Revisions to the Cairns Plan Hill Slope and Vegetation Conservation

Save Our Slopes Community Action Group Incorporated
and
Whitfield Hill Community Action Group Incorporated
October 2008
Revision 3

5.17 The Rocks, Jenkins Access Road – Hillslope #'s 34 & 35

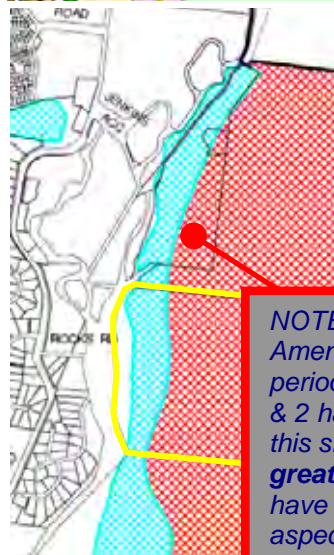
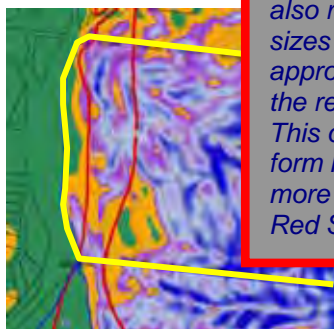
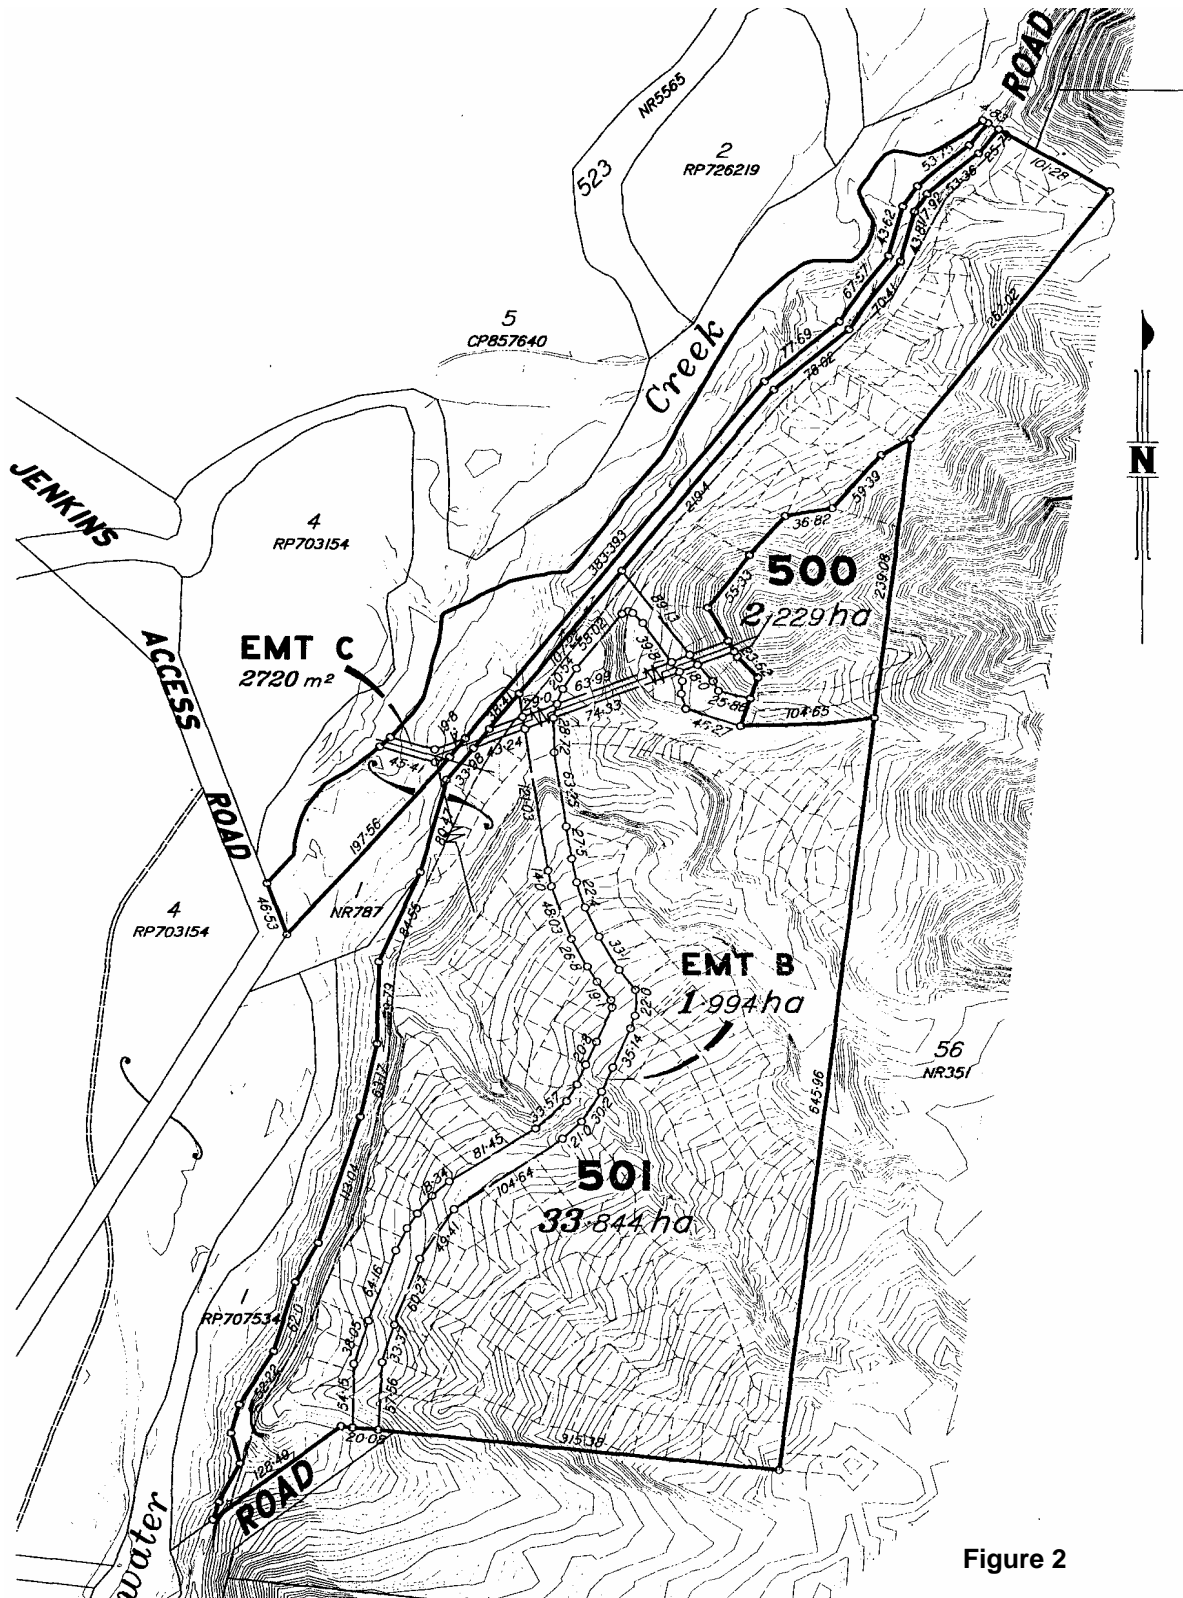
The proposed residential 1 designation extends to the 80m contour line. Residential 1, LD Residential & Rural 1 designations are clearly visible from the Redlynch Intake Road and occur adjacent Freshwater Creek which is a Category 1 waterway surrounded by significant vegetation. Development of these allotments will result in visual degradation similar to what has occurred at Redlynch Valley Estate.

As can be seen from the Terrain map to the bottom left of this page and the contour plan on the next page both sites are steep and highly visible. The adjacent Terrain map of Lot 16NR1608 indicates little of the Hillslopes Category 1 area has slopes less than 1:3 and therefore is unsuitable for development or designation as Hillslopes Category 1. Accordingly it should be re-designated Category 2. LD Residential Lot designations are located on a prominent spur and will lead to a lessening of hillslope scenic amenity in this majestic landscape.

NOTE: Subsequent to the Amendment 2007 consultation period Hillslopes categories 1 & 2 have been removed from this site completely. This is of great concern as CRC will have no control over any aspects of visual amenity – it also reduces allowable lot sizes from 1000m2 to approximately 600m2 under the reconfiguration of lot code. This development in its current form has the potential to be more visually intrusive than the Red Scar (Redlynch Rise)

Development of hillslopes #'s 34 & 35 will result in visual degradation of the scenic amenity of the hillslopes similar to that which has occurred at Redlynch Valley Estate. However this development is at the entrance of the Redlynch Valley.

Conservation

Hillslopes Category 2 (Urban)

5.18 Whitfield – Hillslope # 36
 Lot 13 NR5512 & Lot 22SP147762

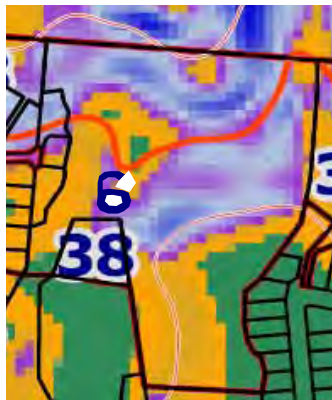
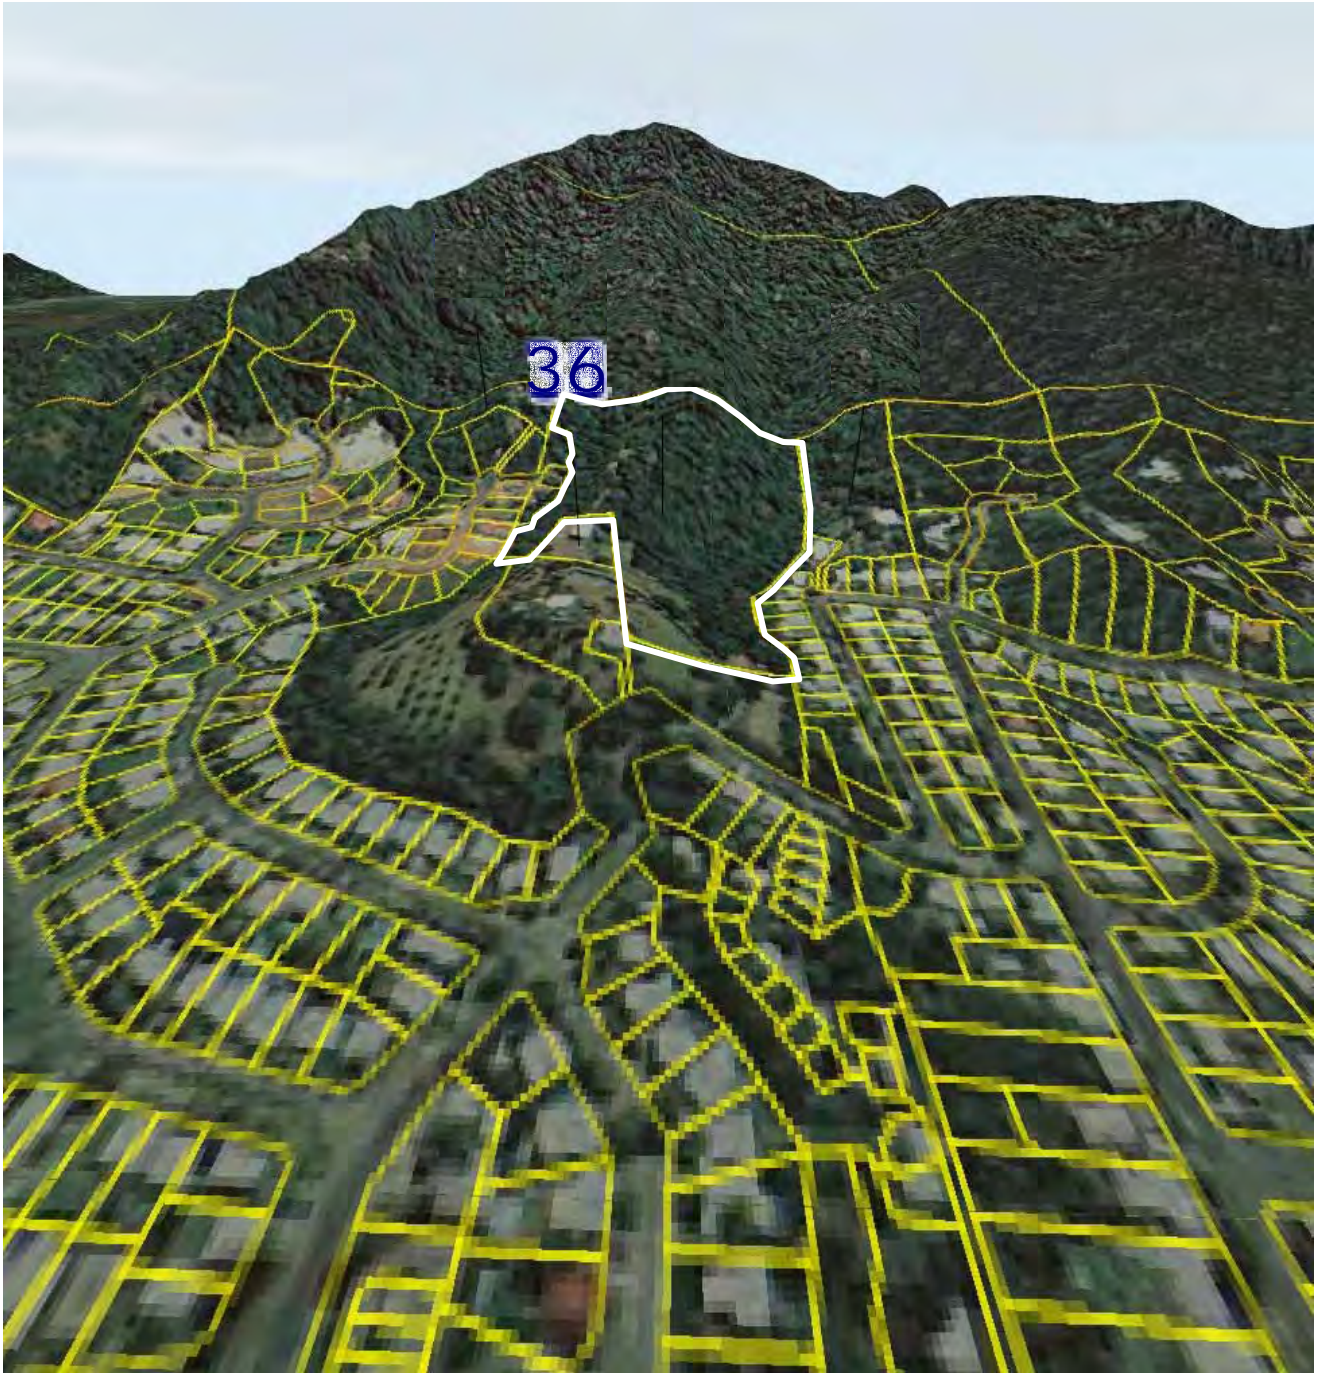
Cairns Plan and Draft:	L.D. Residential
Proposed by SOS:	Conservation
Comment:	Planning designation inconsistent with identical conservation designation to the north refer Aerial Photo mosaic on next page.

Cairns Plan and Draft:	Hillslopes Category 1 (Urban)
Proposed by SOS:	Hillslopes Category 2 (Urban)
Comment:	Hillslope # 36 is highly visible from Edge Hill and Whitfield areas. Area more suited to National Park than L.D. Residential.

Cairns Plan and Draft:	Varies
Proposed by SOS:	Vegetation Category 1
Comment:	Cairns City Council to recheck the Vegetation Category to this area. Recent site observation indicates this hillslope should be redesignated Vegetation Category 1 as is of equal quality as adjacent vegetation in Whitfield National Park.

Hillslope # 36 is a highly visible hillslope from Whitfield and EdgeHill areas and is an integral part of the remaining hillslope scenic amenity.

5.20 Flying Leap Area – Hillslope #'s 46 & 47
 Lot 13 NR5512 & Lot 22SP147762

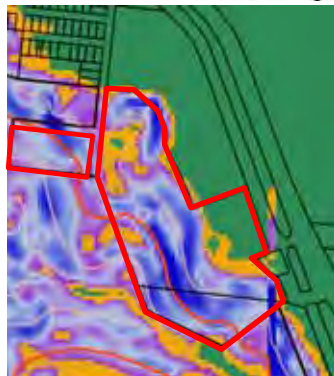
Cairns Plan:	Open Space
Proposed by SOS:	Conservation
Comment	Highly visible hillslope visible from Captain Cook Highway and when arriving to Cairns from airport road (eg visitors first impression of Cairns). <i>Open space designation will not adequately protect the visual amenity of this steep highly visible slope which requires rehabilitation.</i>

Cairns Plan and Draft:	Nil
Proposed by SOS:	Hillslopes Category 2 (Urban)
Comment	Hillslope requires protection in regards to visual amenity due to prominent location. <i>Cairns Plan Amendment 2007 proposes to redesignate lot above 10m to Hillslopes Category 1. Due to prominence of this hillslope from the highway SOS propose this be reviewed to Category 2</i>

Photograph 21 - View of Hillslope # 59 from Bruce Highway

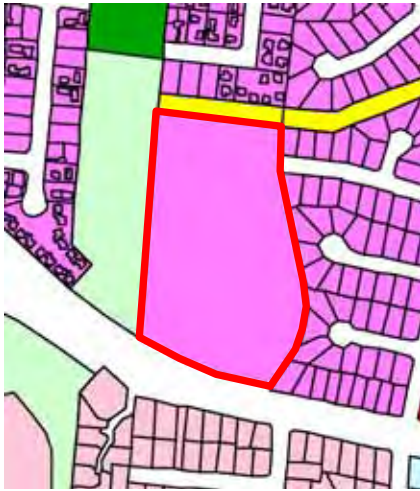
Cairns Plan and Draft: Rural 1
Proposed by SOS: **Conservation**
Comment: This is an outlying spur of Mt Sheridan 30m to 130m AHD with gradients mostly 1 in 2, and 1 in 3 on the easternmost extension to the Bruce Highway.

Cairns Plan and Draft: Hillslopes Category 1 (Urban)
Proposed by SOS: **Hillslopes Category 2 (Urban)**
Comment: Hillslope with high scenic value due to its prominent location. Acts as green belt visually breaking areas of urban sprawl.
